International Isotopes Inc.

November 16, 2006

Subject: Request to Amend NR-1235-S-102-S.

Source Label Example

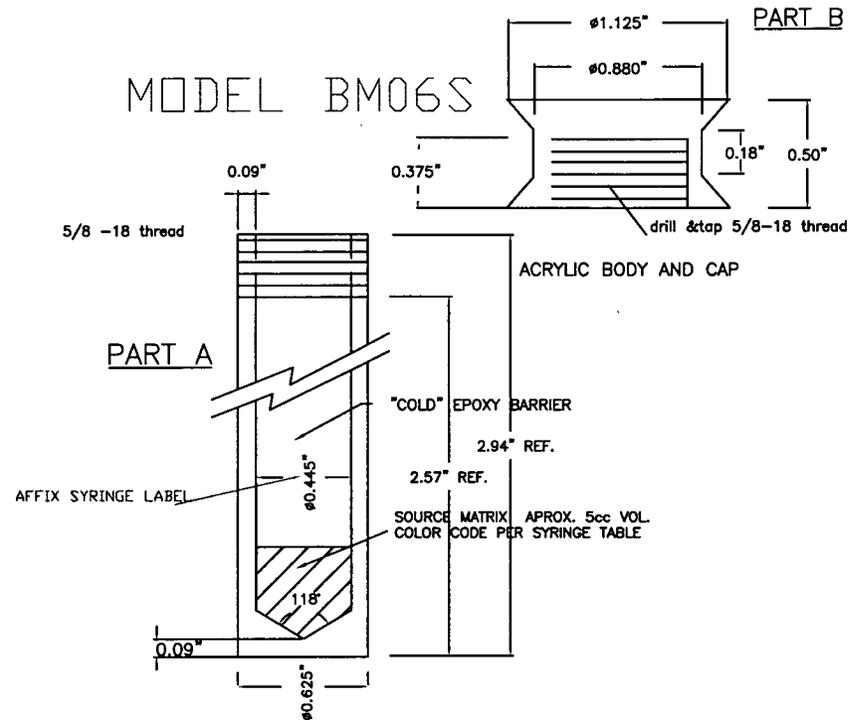
Page 3, LABELING: Revise the labeling paragraph to read:

“Each source and storage pig is conspicuously labeled with the source isotope and activity and bears the warning “Caution: Radioactive Material” as well as the trefoil radiation symbol in magenta on a yellow background, the designer’s name, and the name of the manufacturer. Each label also contains the source model number, serial number and a reference date for the source activity. The label will be affixed to the exterior of the source and will be laminated so that the label remains legible and is not degraded as a result of normal use. Refer to Attachment 1”.

A new source label is provided for use in Attachment 1.
